20/00846/HHFUL Acoustic Housing to gable end – 21 Cherryfields

Objections to the proposed 4 AC units and their acoustic housing on the gable end.

Appendix 1 Objection Report-AC Acoustic housing

This photograph shows the approximate area the acoustic housing for 4 units will cover.

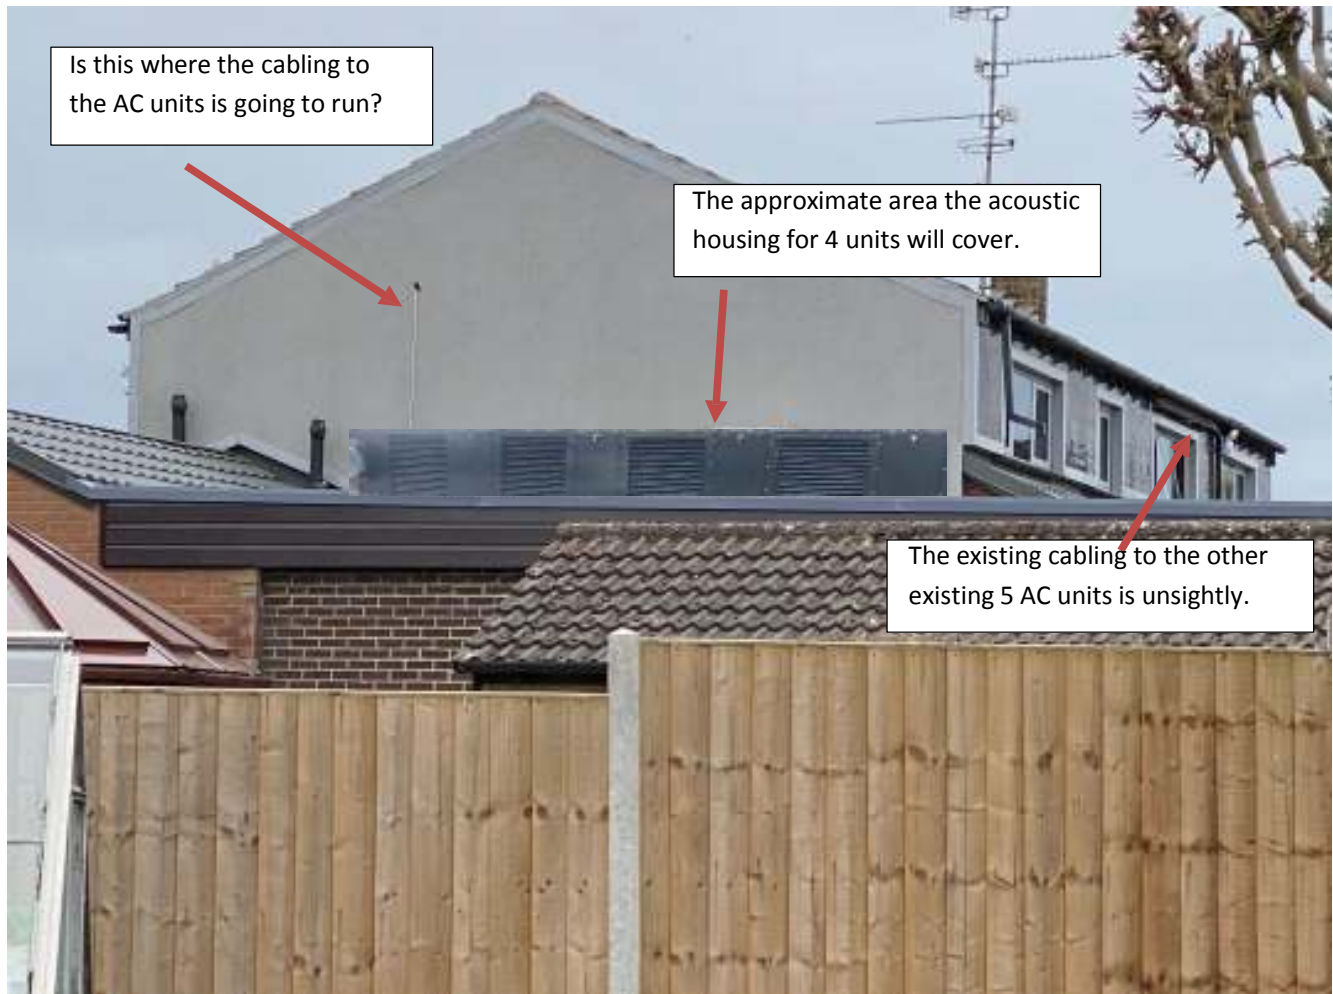
I am focusing my objection on the acoustic housing for the four air conditioning units planned to be sited on the flat roof and attached to the gable end of the first floor. Their size will impact the view of the neighbouring gardens, nos. 22, 23, 24 and 25.

The proposed acoustic housing for the 4 AC units is a significantly sized commercial type structure that will be easily viewed from the gardens of 22, 23, 24 and 25 Cherryfields. The view of this structure will have a big impact on how we enjoy our gardens.

This planned, large acoustic housing structure (see photo 2) is going to have an immense visual impact on no.22, 23, 24 & 25 Cherryfields.
